CONTRACT CHANGE ORDER MEMORANDUM

TO: DEANNA VILCHECK / JEANNETTE BALDERRAMOS			FILE: E.A. 04 - 0120M4
FROM: JEANNETTE BALDERRAMOS			CO-RTE-PM 04-ALA-80-1.6/2.7
			FED. NO. NO FED AID
CCO#	SUPPLEMENT#:	Category Code:	CONTINGENCY BALANCE (incl. this change)
1	0	AJZZ	\$5,079,361.00
COST: \$250,000.00		INCREASE <input checked="" type="checkbox"/> DECREASE <input type="checkbox"/>	HEADQUARTERS APPROVAL REQUIRED? <input type="checkbox"/> YES <input checked="" type="checkbox"/> NO
SUPPLEMENTAL FUNDS PROVIDED: \$250,000.00		IS THIS REQUEST IN ACCORDANCE WITH ENVIRONMENTAL DOCUMENTS? <input checked="" type="checkbox"/> YES <input type="checkbox"/> NO	
CCO DESCRIPTION: Flagging & Traffic Control			PROJECT DESCRIPTION: CONSTRUCT BRIDGES AND ROADWAY, AND ELECTRICAL SYSTEM
Original Contract Time:	Time Adj. This Change:	Previously Approved CCO Time Adjustments:	Percentage Time Adjusted: (including this change)
1140 Day(s)	0 Day(s)	0 Day(s)	0 %

CCO DESCRIPTION: Dispute Review Board (Caltrans Portion)		PROJECT DESCRIPTION: CONSTRUCT BRIDGES AND ROADWAY, AND ELECTRICAL SYSTEM		
Original Contract Time: 1140 Day(s)	Time Adj. This Change: 0 Day(s)	Previously Approved CCO Time Adjustments: 0 Day(s)	P

CONTRACT NO. 04-0120M4
 CONTRACT CHANGE ORDER NO. 23
 SHEET 12 OF 13

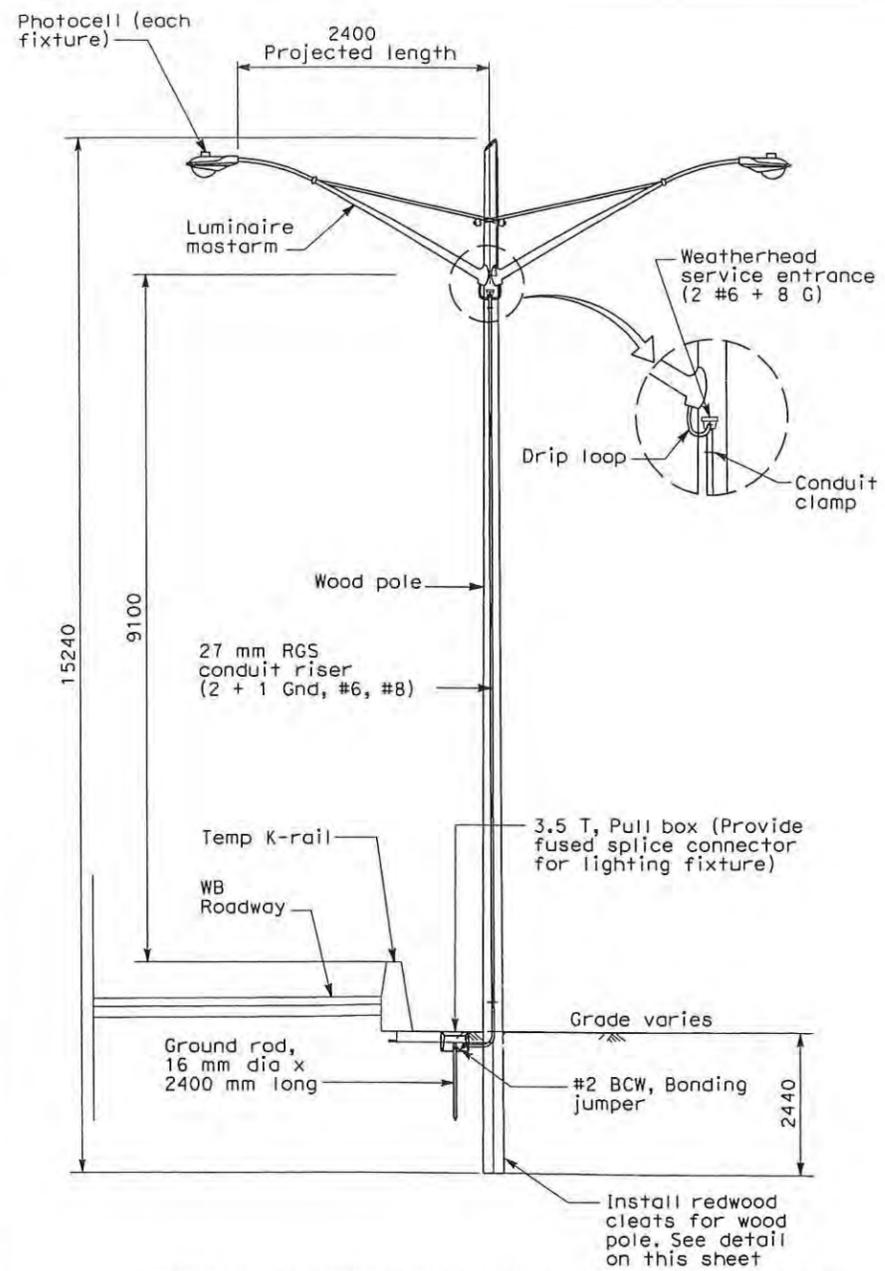
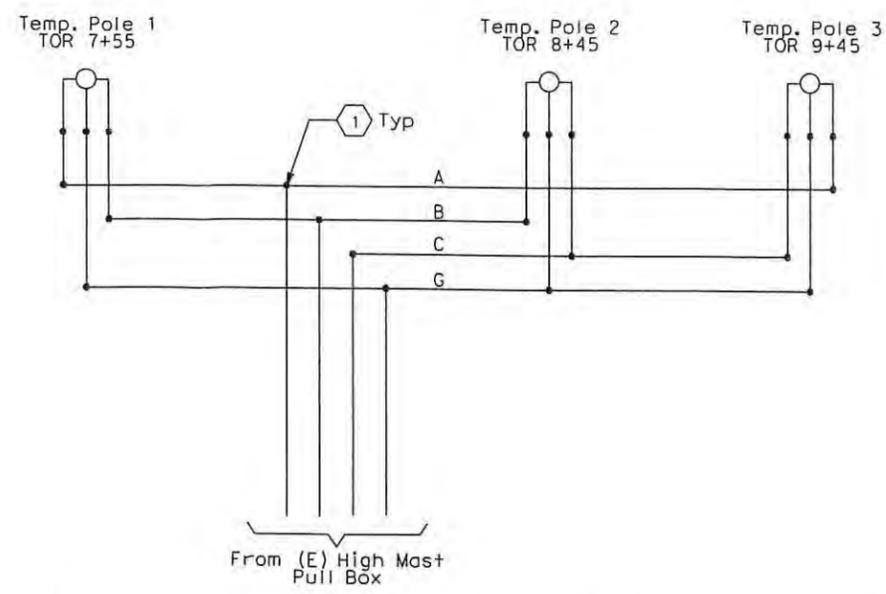
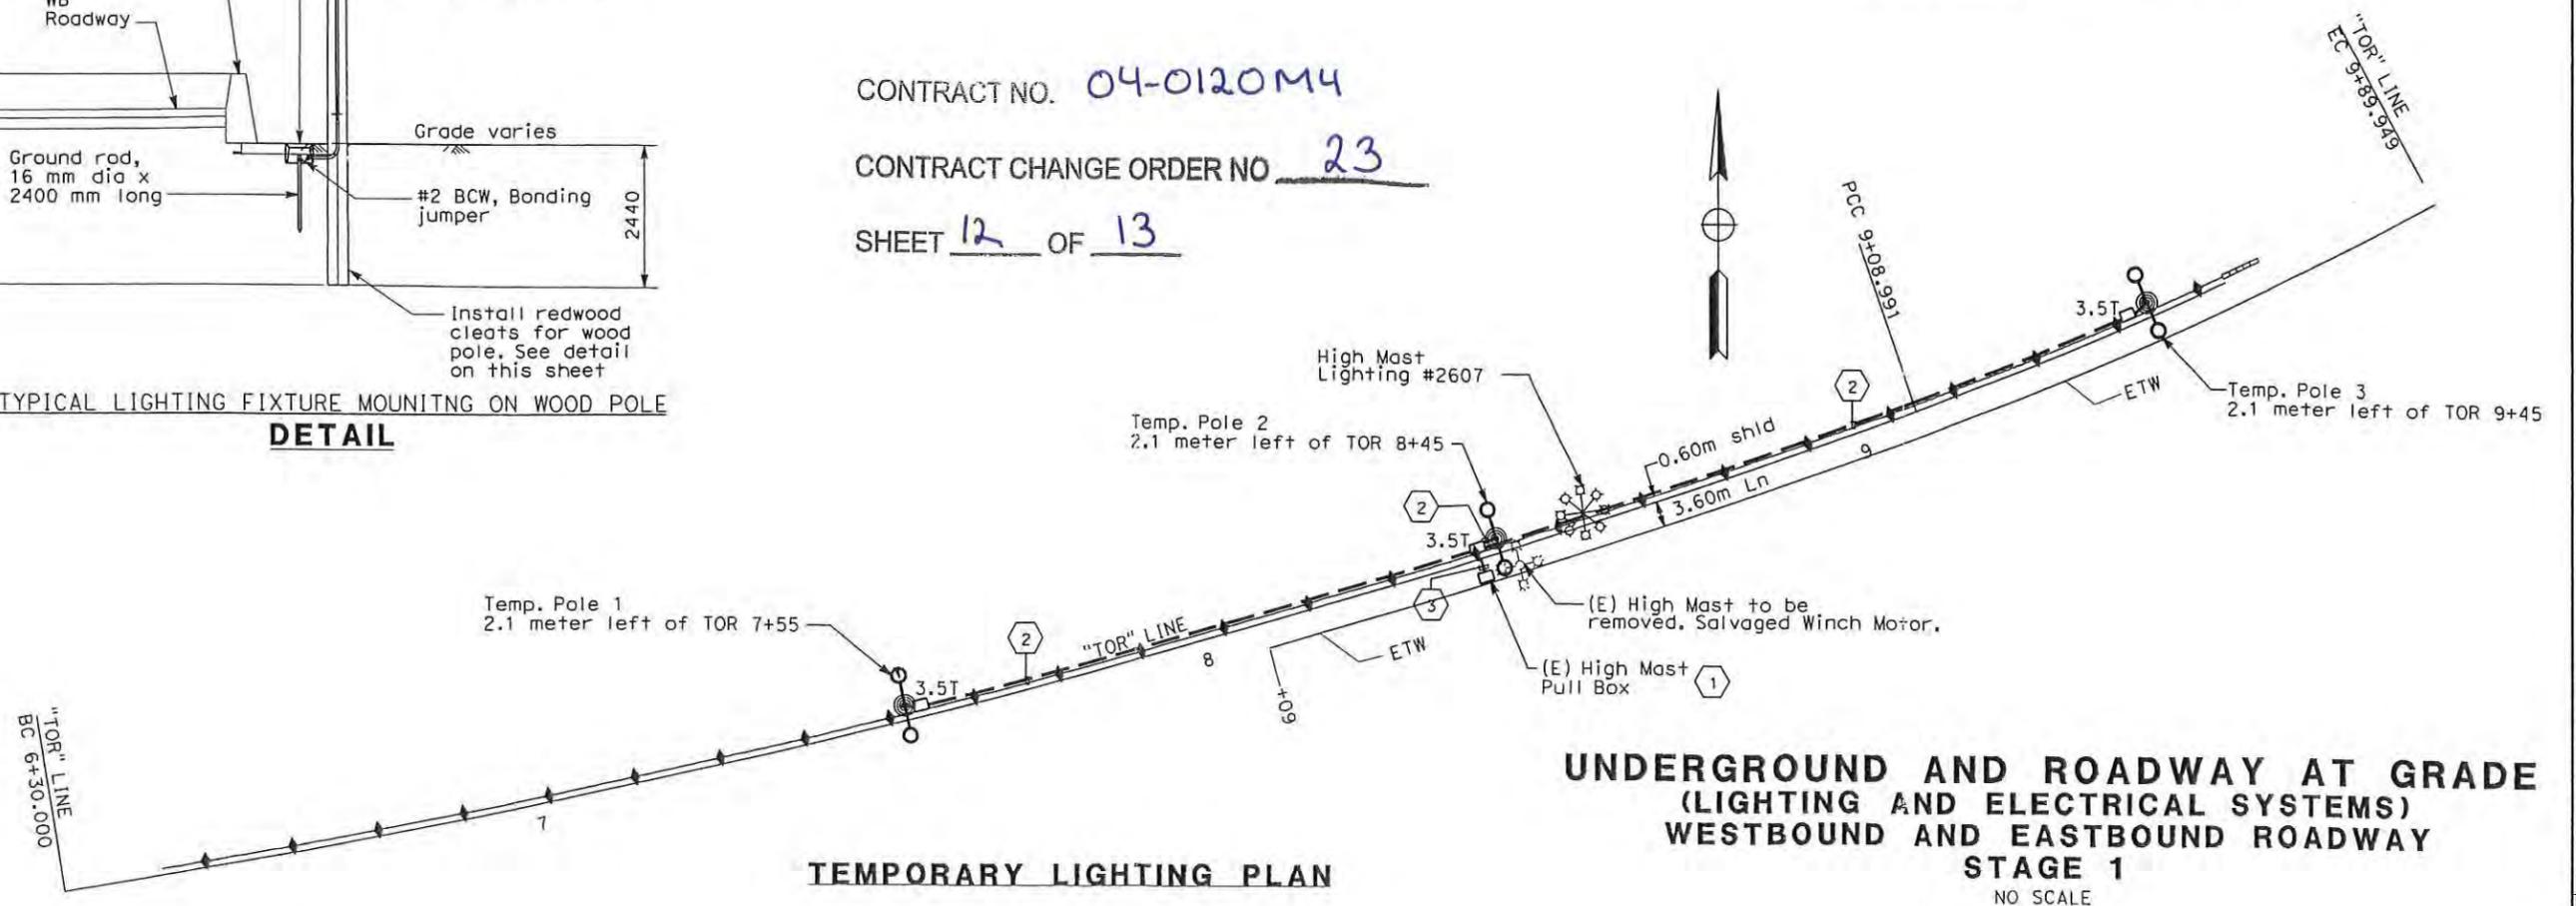
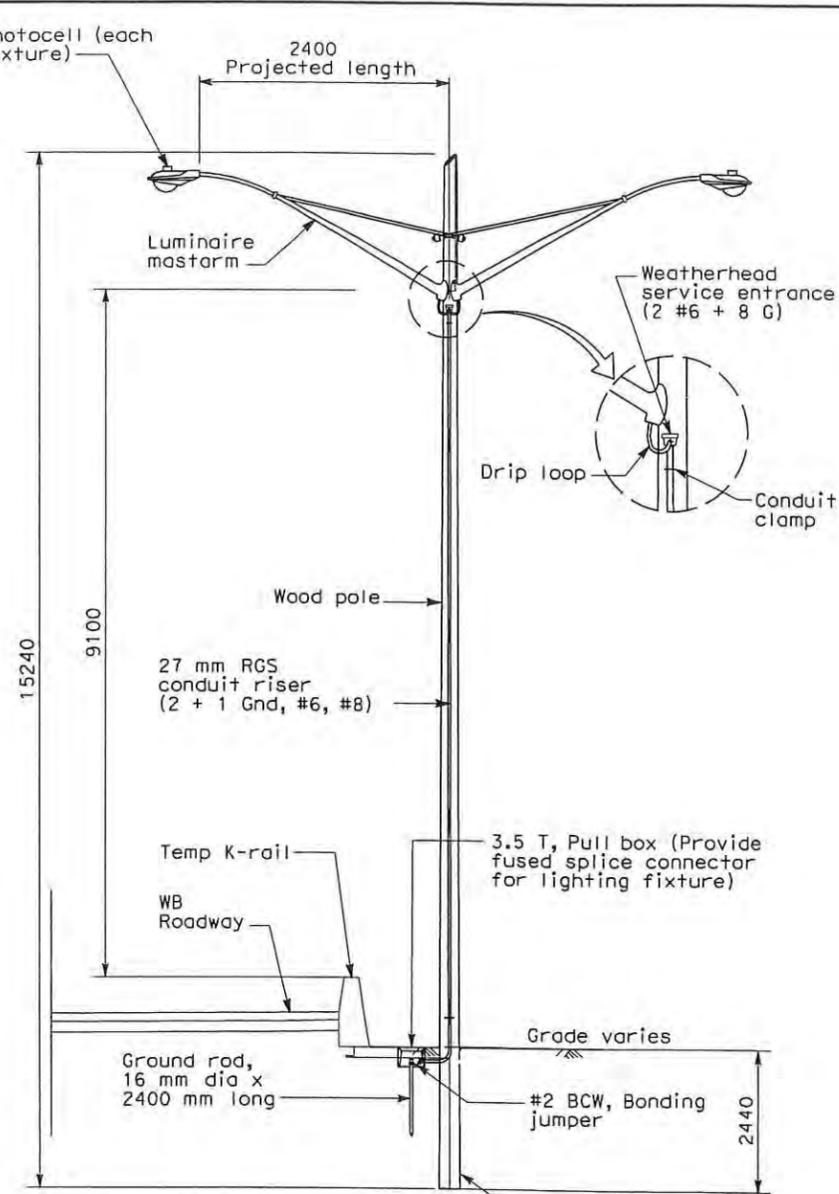
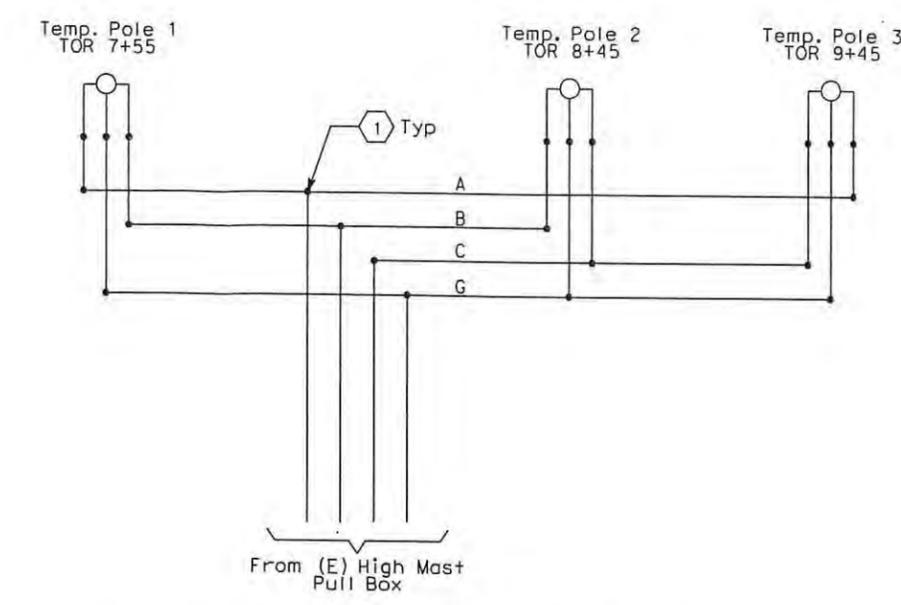
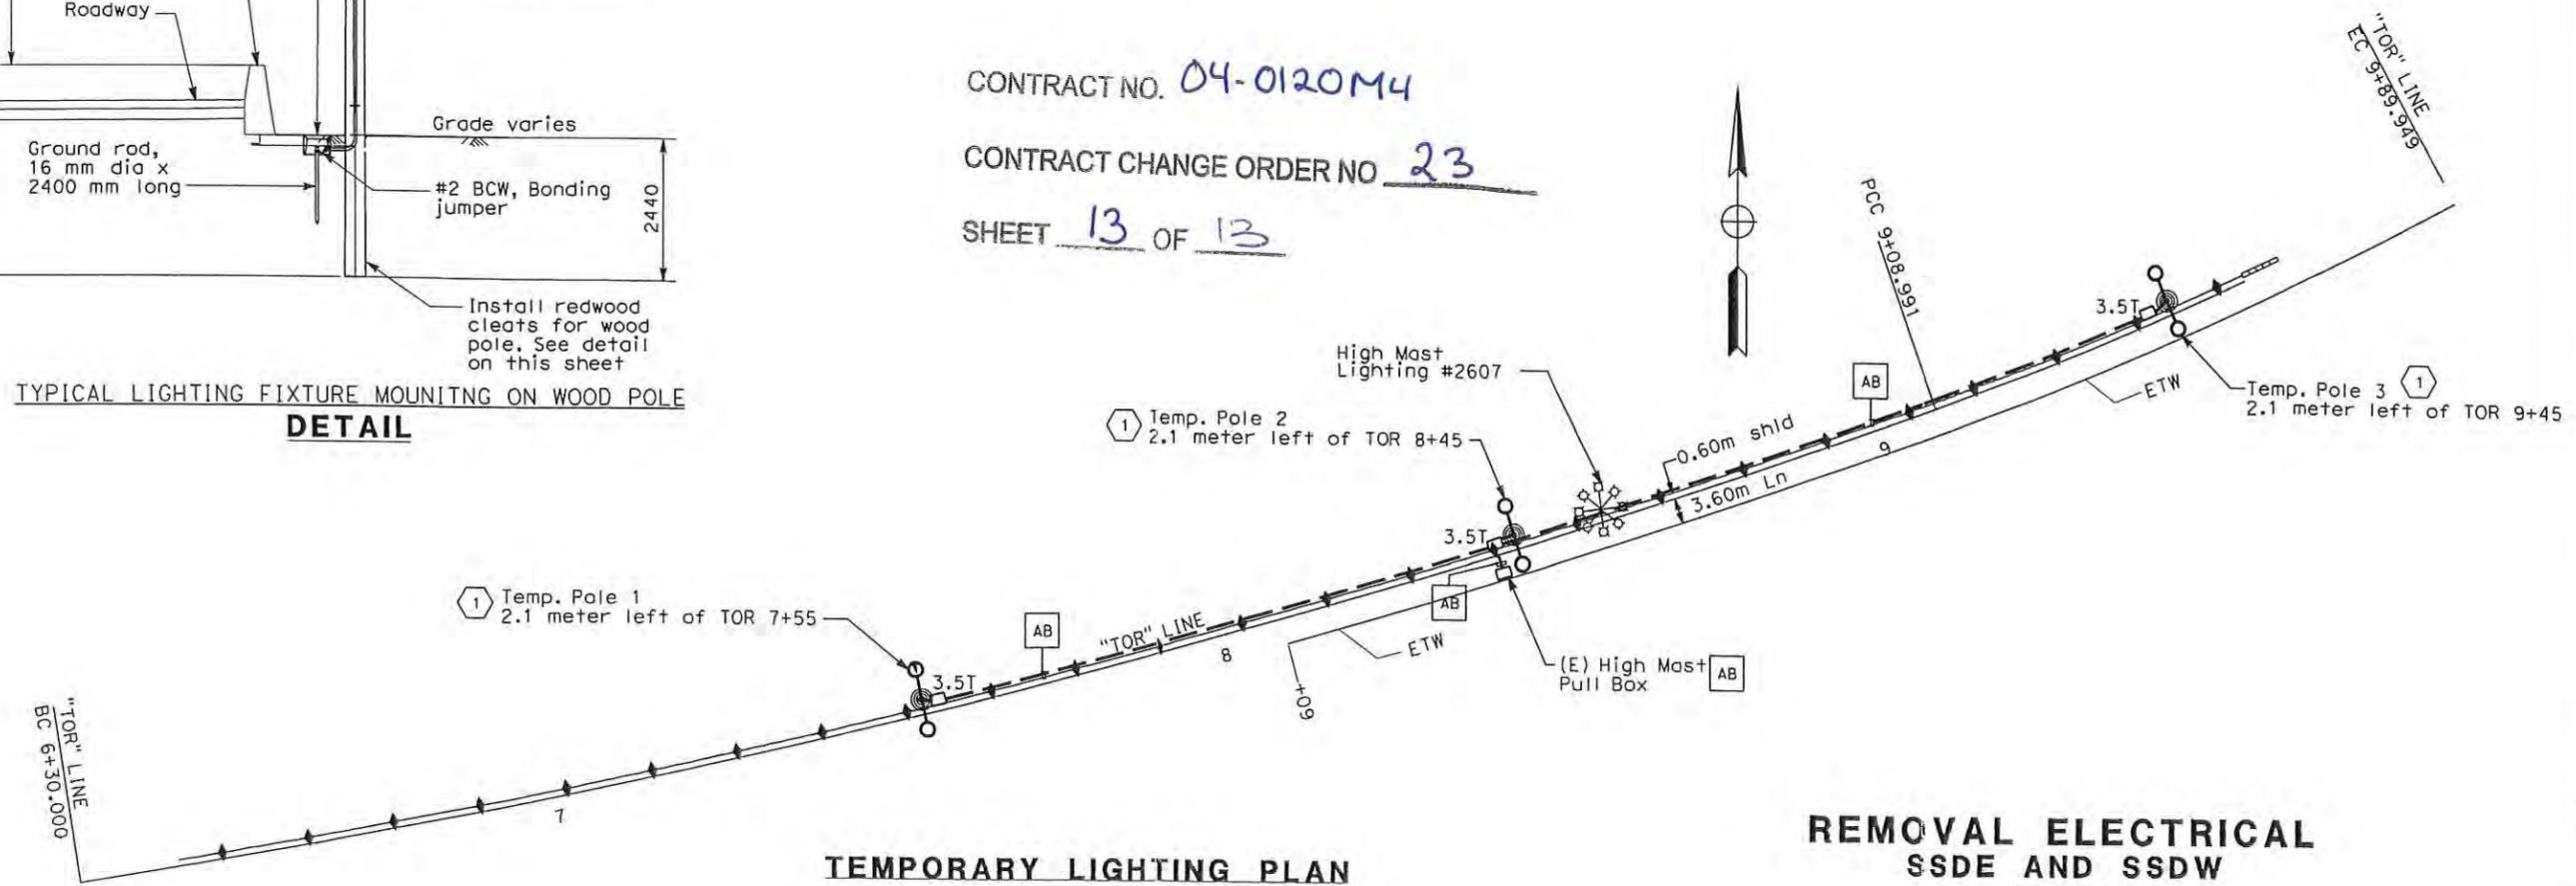
Install and remove, when no longer required, temporary lighting as determined necessary by the Engineer, and as shown on contract plan sheets 191R1, 192R1, 261A, and 394A, sheets 10 through 13 of this change order.
